FINAL REPORT

Review of Ballast Water Tank 93 Out-of-Service Inspection Report and Tank Repairs

PWSRCAC Contract # 5081.25.01

William Mott P.E.

Figure 3 – Schematic of Tank 93 Perimeter Section

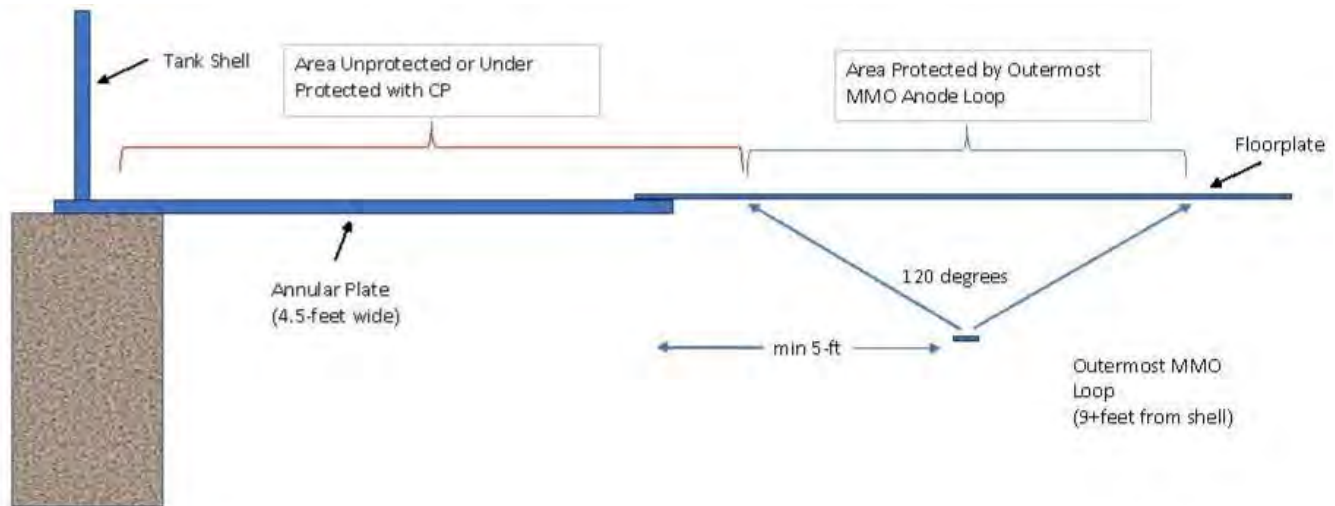
The CP ground bed for the Tank 93 CP system consists of an MMO grid distributed throughout the area beneath the tank floorplate. The CP design includes a separate MMO loop intended to protect the tank's annular plates. According to the design drawings, the outermost anode loop for the existing CP system is more than 9 feet from the tank shell. In this position, the perimeter anode is located beneath the floorplate and not beneath the annular plate (Figure 3).¹

The location of the perimeter anode is such that it is not physically possible to provide sufficient CP current to the annular plate and first few feet of the perimeter plates.

This anode configuration does not protect the annular plates and perimeter floor plates for the following reasons:

- First, the annular plate and floorplate are welded together and therefore electrically continuous. The MMO loop intended to protect the annular plates and perimeter plates will distribute current primarily via the lowest resistance pathways. In this case, assuming similar backfill resistivity, the current will go to the closest steel, which is the regular floorplate immediately above the anode loop, not the perimeter or annular plate.
- The ratio of floorplate surface area to anode length is significantly larger at the tank perimeter than it is closer to the center. Without the ability to drive the current from the

perimeter anode separately from the remainder to the floorplate, the CP current density to the perimeter floorplate and annular plate will be significantly lower than the rest of the floor.

- Distribution of CP currents is directed by the resistance of the pathway between the structure being protected (the tank floor) and the anode. The longer the distance between the tank floor and the anode, the greater the electrical resistance. The CP current moves along the lowest resistance path and will protect the areas of the floor that are closest to the anode because the electrical resistance is lowest along that path. The general rule of thumb is that the anode can drive current to a pattern within a 120-degree arc from the anode. Beyond that area, the pathway resistance becomes too high for CP current to distribute.

- The MMO loop that is intended to protect the annular plate and perimeter floorplates is tied to a single circuit that cannot be adjusted independently of the floorplate system. Even if the system had the ability to independently power the MMO loop nearest to the annular plate, the resulting CP current would still go predominantly to the floorplate immediately above the perimeter anode loop and will not measurably impact the annular plate or outer perimeter plate surfaces.

- Taku recommends the CP systems for Ballast Water Storage Tank 93 be upgraded in the perimeter areas to protect those areas from corrosion.
- Taku recommends the CP system monitoring tubes be slotted in the perimeter area to allow CP monitoring of that area, to ensure effective corrosion mitigation.

Figure 4 – Predicted Versus Actual Corrosion Depths for Tank 93

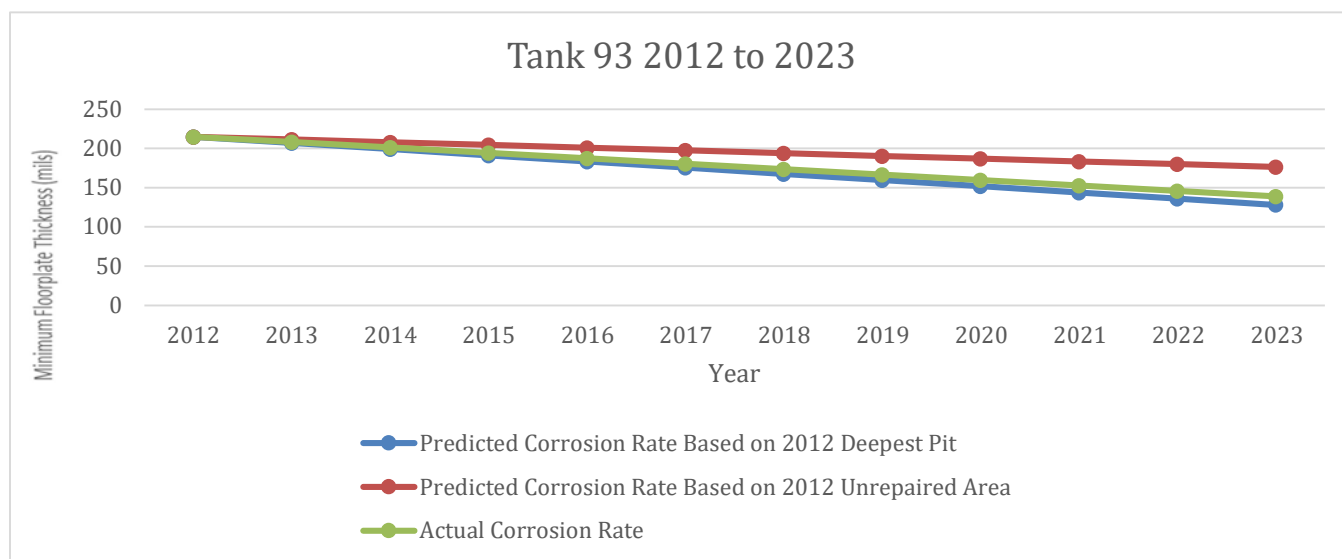
The deepest pit discovered during a VMT tank inspection should be utilized to set the next service interval, regardless of repair thresholds. Revisiting the 2012 inspection and repair results provides another data point supporting this approach. Figure 4 graphically illustrates the predicted and actual corrosion rates for Tank 93 for the 2012-2023 period based on the 2012 inspection and current inspection findings.

The red line in the graph represents the predicted corrosion rate using the deepest unrepaired pit from 2012 (as allowed by API 653). Based on the deepest unrepaired pit after the 2012 inspection (215 mils RFT), the predicted corrosion rate for the Tank 94 floorplate was 3.5 MPY and the predicted deepest pit in 2021 was 180 mils RFT.

The use of the deepest pit from the 2012 inspection (171 mils RFT) to calculate corrosion rate and predict the deepest pit in 2023, resulted in a 2012-2023 predicted corrosion rate of 7.9 MPY and a predicted deepest pit (in 2023) of 128 mils RFT. This is represented by the blue line in Figure 4.

The actual deepest floorplate pit identified in 2023 was 139 mils RFT, representing a corrosion rate of 6.9 MPY. This is represented by the green line in Figure 4.

Using the 2012 deepest pit to define the 2012-2023 corrosion rate, the actual rate of corrosion was over-estimated by 14%. Using the deepest unrepaired pit (from the 2012 inspection) to predict the Tank 93 floorplate corrosion rate between 2012 and 2023, the actual corrosion rate was underestimated by 49%.
